3.0 DRAWINGS AND DESCRIPTION OF PROPOSED CHANGES

3.2 BUILDING 2 UPPER FLOORS - SEVENTH FLOOR

TOTTENHAM HALE CENTRE ISLAND SITES

PROPOSED L08 FLOOR PLAN

Proposed

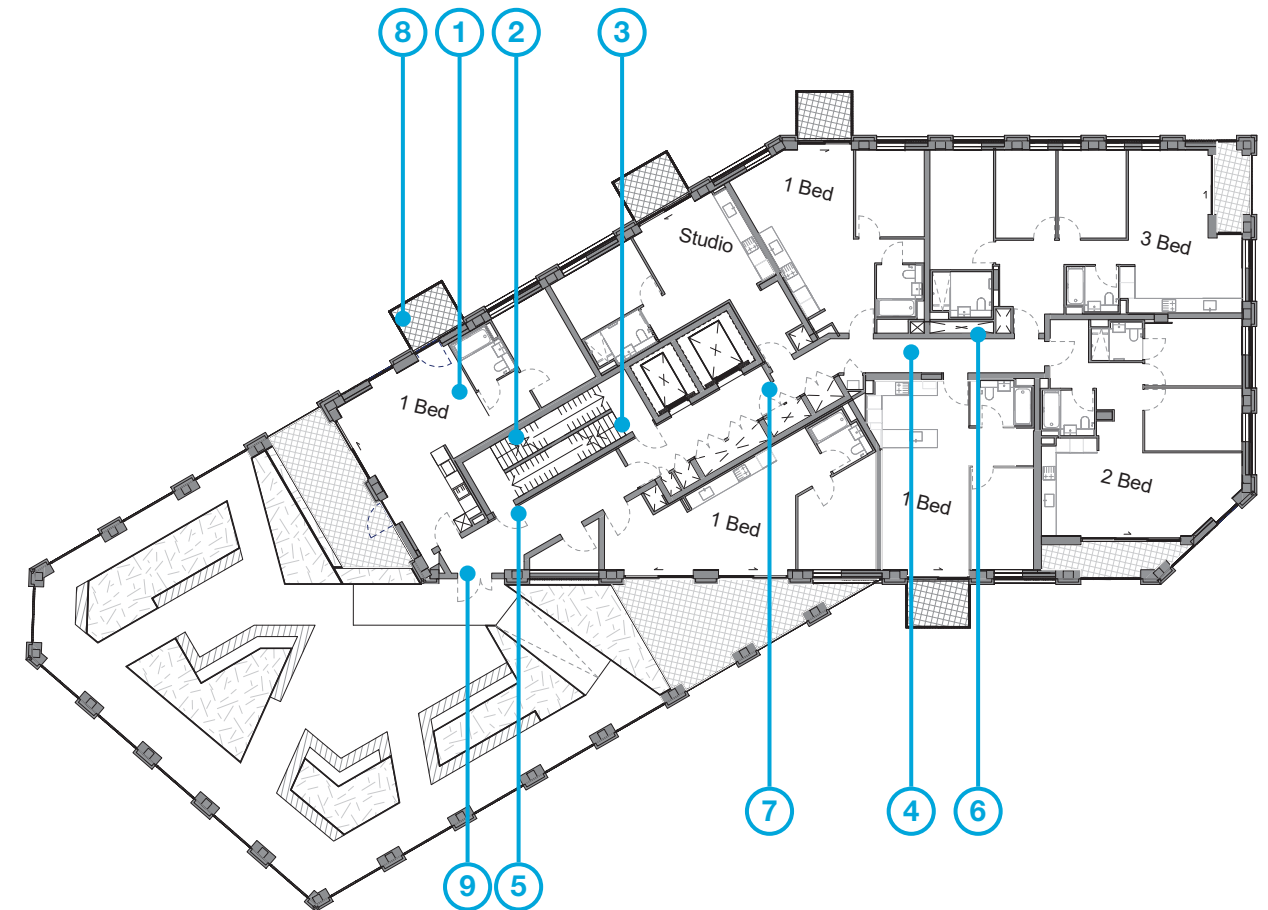
1. The layout of the 1 bed apartment adjacent to the stair has been revised to respond to the new stair arrangement.
2. The communal stair has rotated through 90degrees to allow a second stair to work in conjunction.

3. A second fire escape stair has been added between ground floor to upper levels.
4. The communal corridor has reduced in width from 2m to 1.5m to accommodate the revised riser layout.

5. Due to the addition of the second stair, the position of the access to the stairs has changed to resolve level changes across all floors.
6. Service risers have been relocated within the core following the addition of the second staircase.

7. Additional doors have been added within the communal corridors to comply with the latest fire strategy.
8. Projecting balcony added between levels 7-11 to compensate for loss of recessed balcony.

9. The line of the façade to access the terrace has been updated to allow the communal corridor to extend and provide access to the adjacent 1 Bed apartment – all due to the revised stair arrangement.
